Figure 1. Cable System - Prior Art

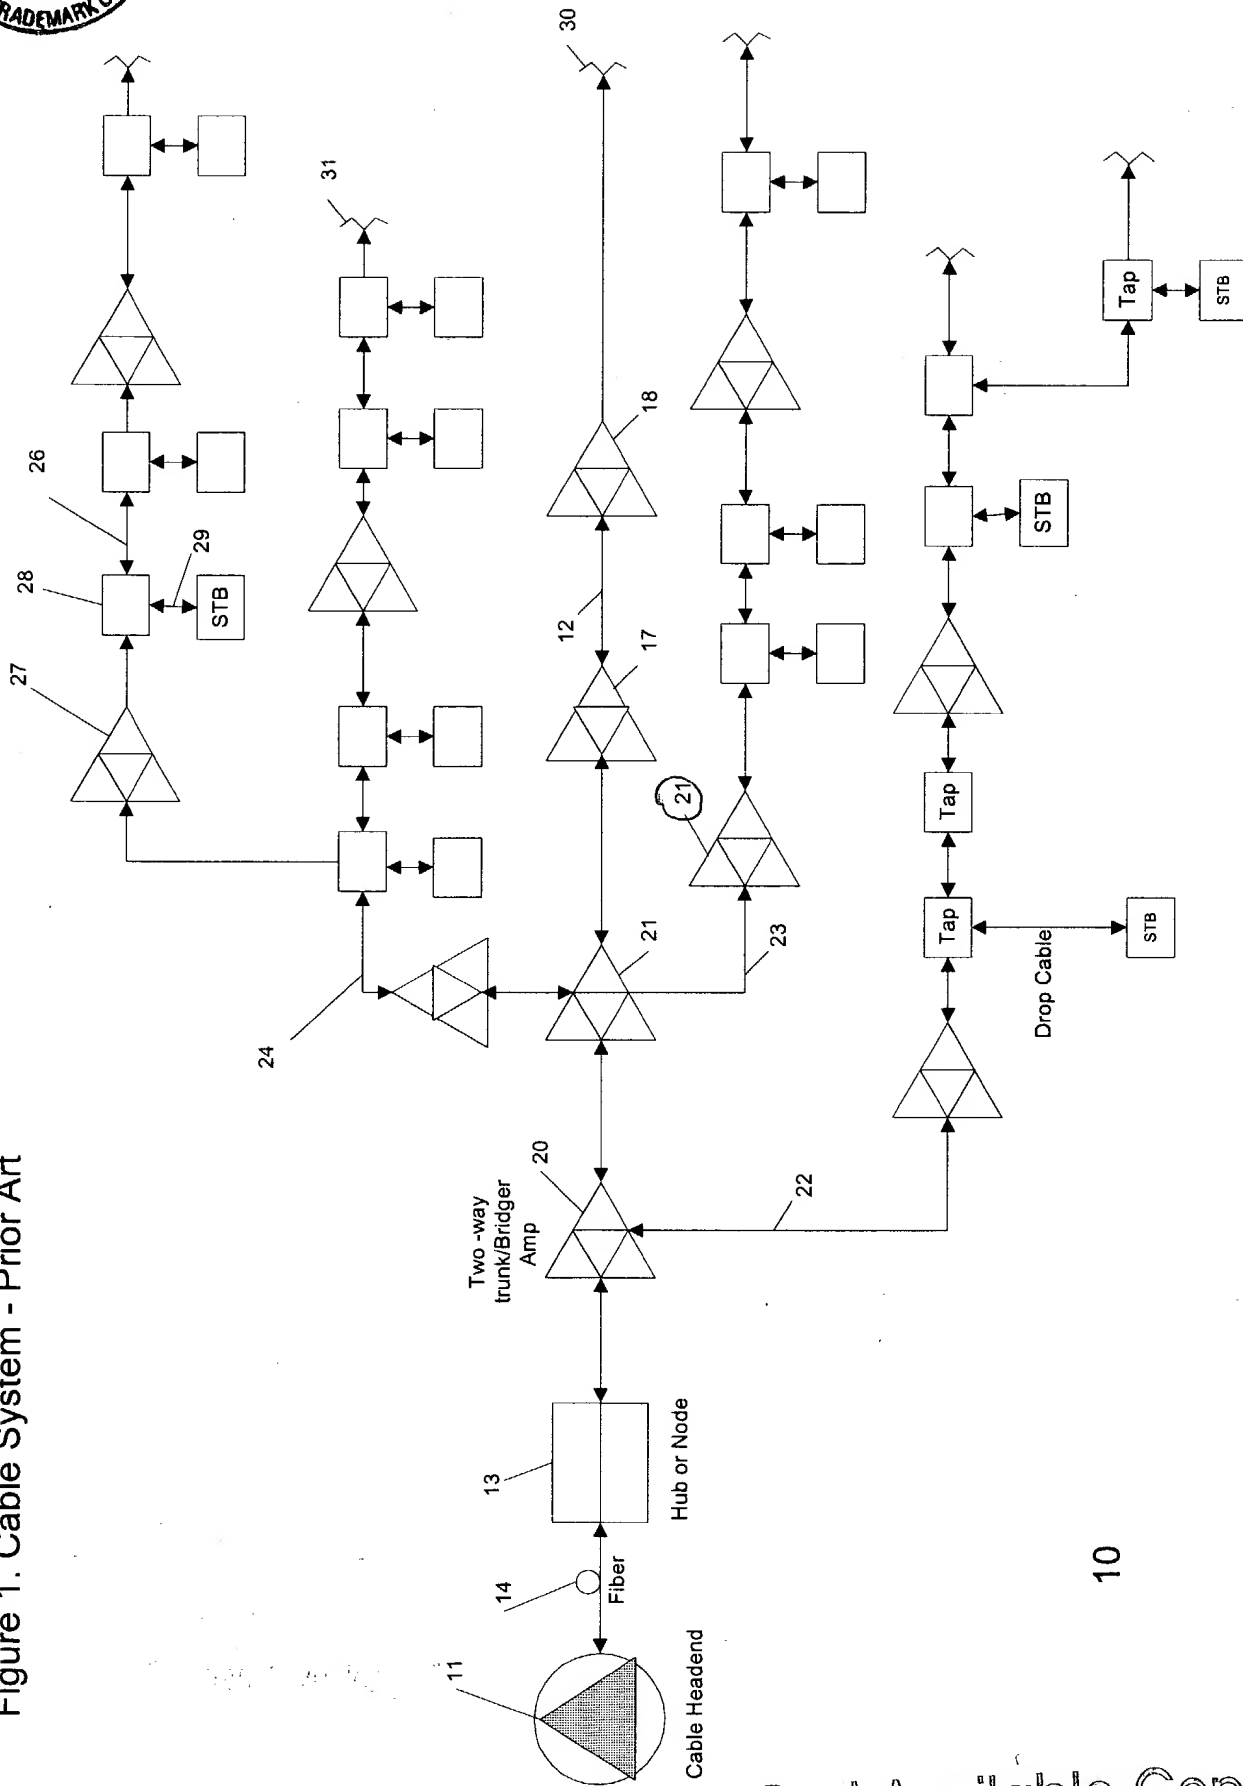
The drawings are being corrected and submitted herewith as directed by the examiner.
